Category: SN3500 INSTALLATION DRAWING

Title: KCS-55 REMOVAL (REF)

Size B Document Number 82005-10 Rev A1

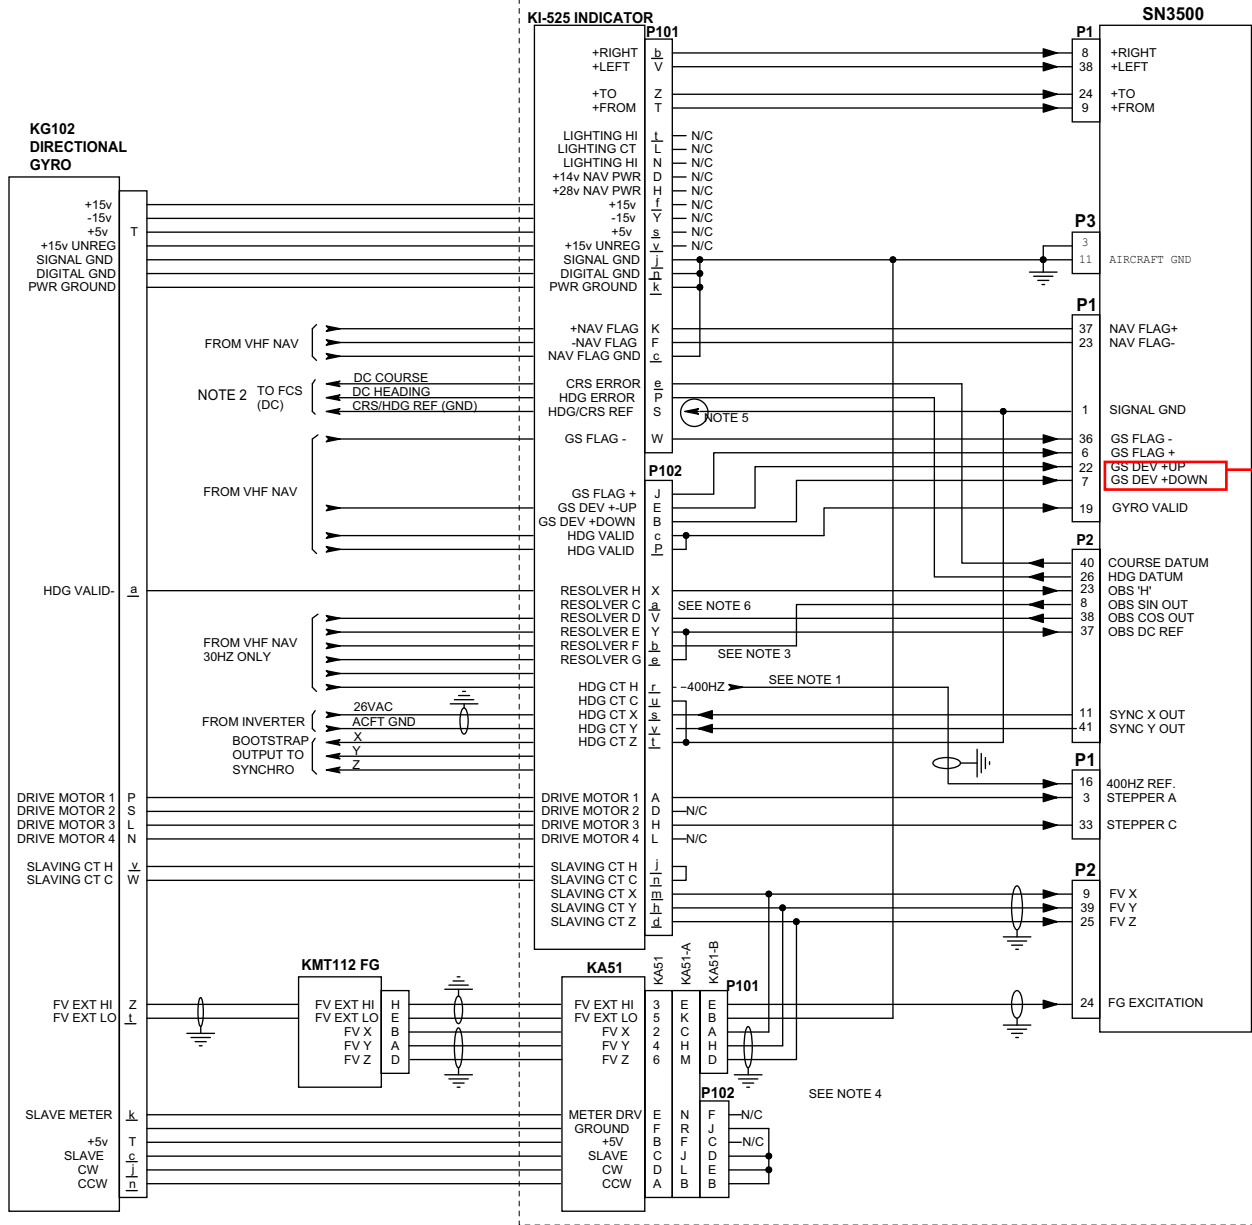
These two labels are swapped over
